August 30th, 2024

**Re: La Plata Apartments
6000 4th St NW
Traffic Circulation Layout
Engineer's/Architect's Stamp 08-29-24 (F14D086)**

DRAWING TITLE		
SITE PLAN		
DESIGNED	PROJECT NO	
DRAWN	SCALE	
CHECKED	DRAWING NO	A-100
REVIEWED	DATE	8/6/2024

SITE PLAN

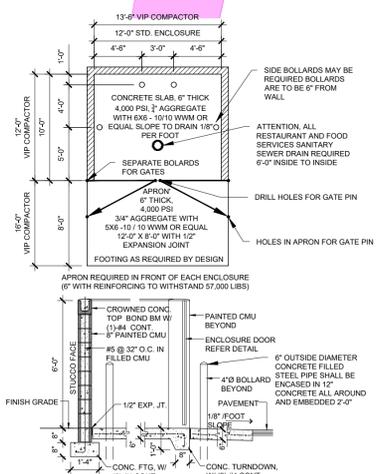
The TCL submittal received 08-11-2024 is approved for Building Permit by transportation. A copy of the stamped and signed plan will be needed for each of the building permit plans. Please keep the original to be used for certification of the site for final C.O. for Transportation. **Sidewalk easement will be the condition for release of final CO.**
